Project Description / Description de projet Ammonia System Upgrade		
Solicitation No./ No de sollicitation 15-22083	Project No./N ^o de projet STJ-5089	W.O. No./N ^o d'ordre de travail
Project Engineer / Ingénieur de projet Rod Griffiths		Date September 18, 2015
<p>Notice: This addendum shall form part of the tender documents and all conditions shall apply and be read in conjunction with the original plans and specifications.</p>		<p>Nota: Cet addenda fait partie intégrale des dossiers d'appel d'offres; toutes les conditions énoncées doivent être lues et appliquées en conjonction avec les plans et les devis originaux.</p>

ADDENDUM NO. 1

MSK-1

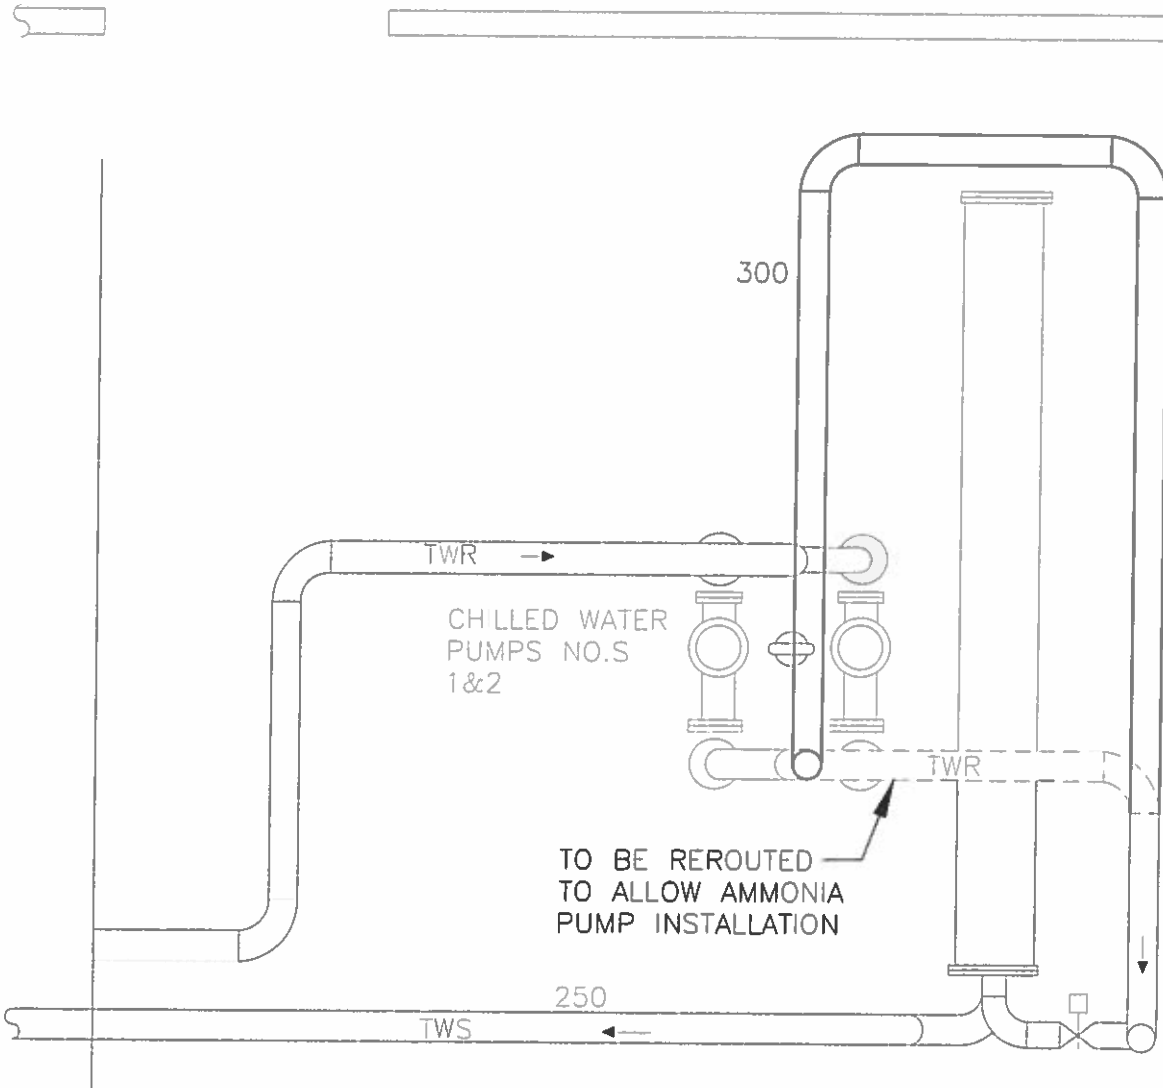
4. **The rerouting of the ammonia piping from the evaporative condensers means that the existing pipe passing through the sump tank will be removed. When removed the old existing pipe will be cut and left in the concrete sump. However, the pipe will need to be capped on both sides of the concrete sump wall. These four caps will be welded on the existing pipe. See sketch MSK-1 attached.**

MSK-2

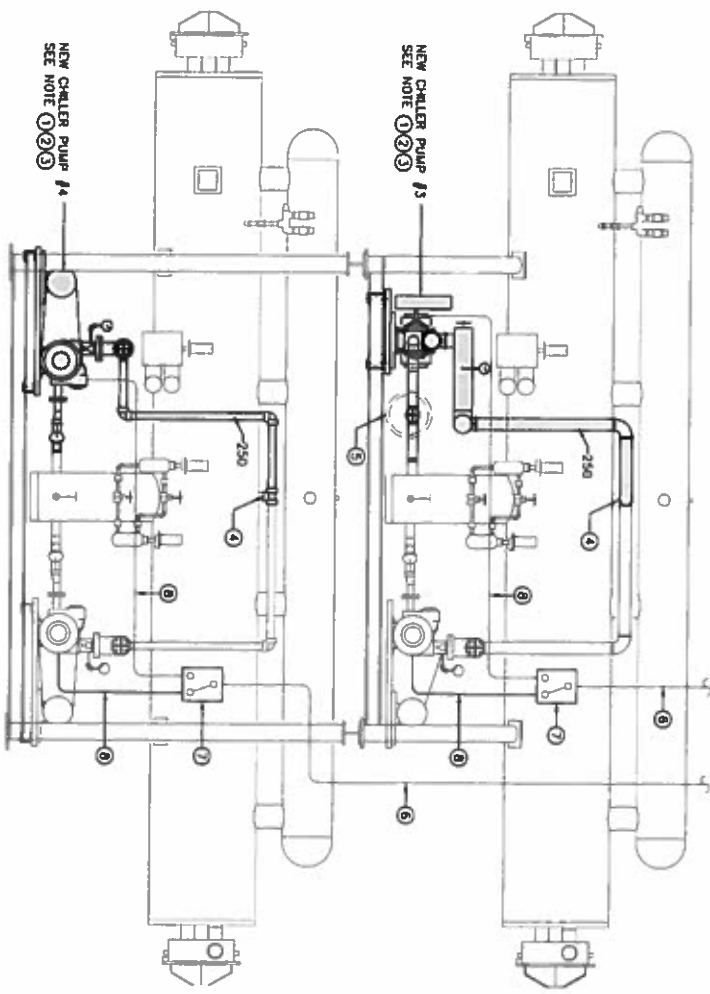
3. **The existing 300mm chilled water main passing along the existing chiller shall be rerouted to allow the second ammonia pump to be installed. This new line is to be reconnected and insulated to match existing. See sketches MSK-2 and MSK-3 attached.**
